Subject: Duke Energy Corporation

McGuire Nuclear Station, Units 1 and 2
Docket Nos. 50-369 and 370

Catawba Nuclear Station, Units 1 and 2
Docket Nos. 50-413 and 414

Response to NRC Request for Additional
Information - TAC nos. MB3222, MB3223, MB3343,
and MB3344) and License Amendment Request
Supplement

Rod Swap
Rod Exchange with Two Test Banks

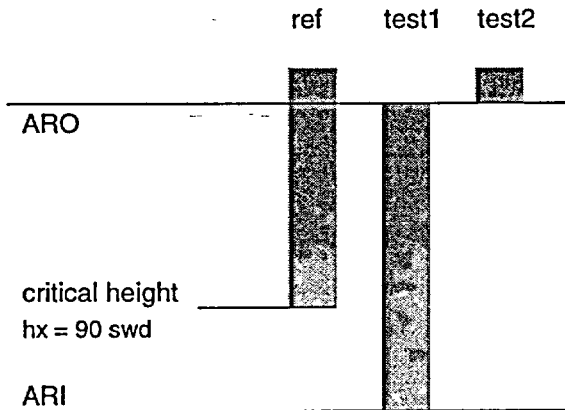
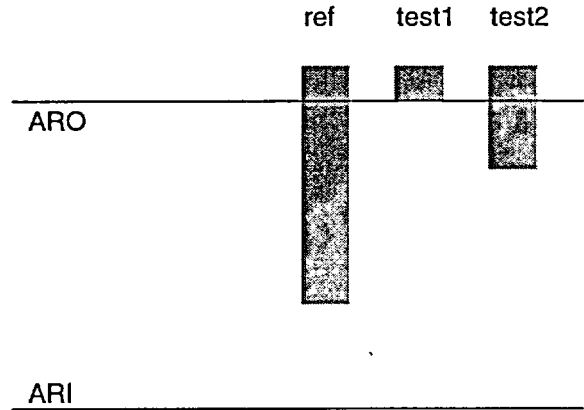
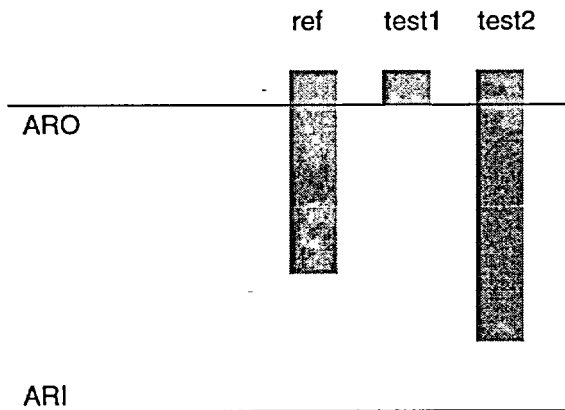
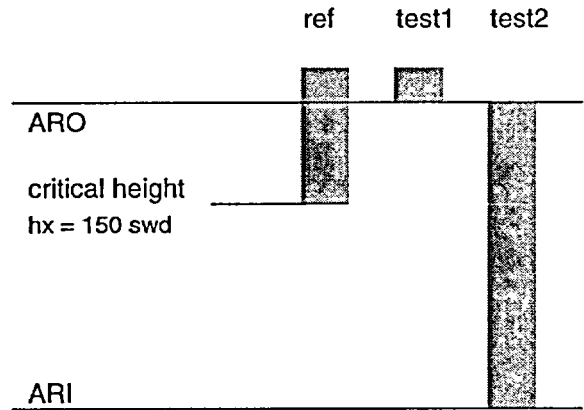
Question 4. The third sentence in Section 3 of the topical report is revised to read: "All other banks are then exchanged with the reference bank or other test banks at constant boron conditions until the measured bank is fully inserted." It is stated, in Attachment 9a - Detailed Listing of Changes to DPC-NE-1003A, that the third sentence in Section 3 is revised to make the report consistent with current procedures. The "Revision History" in the topical report states that this revision [Revision 1] also reflects a refinement in the rod swap to make use of two test banks.

- a. What is the "current procedures"? What is the date of the current procedures?
- b. Are the current procedures the same or different from the one in Attachment 3? The Attachment 3 procedures did not include the exchange of a test bank with other test bank.
- c. If the "current procedures" are different from that of Attachment 3 or 4, provide a copy of the procedures, and appropriately reference it in the report.
- d. Is the statement in "Revision History" referring to this revision? Please explain what the statement means.

Step 1
Measure Test1 Rod Swap

Step 2
Exchange Test1 and Test2

Step 3
Exchange Test2 and Reference

Step 4
Measure Test2 by Rod Swap
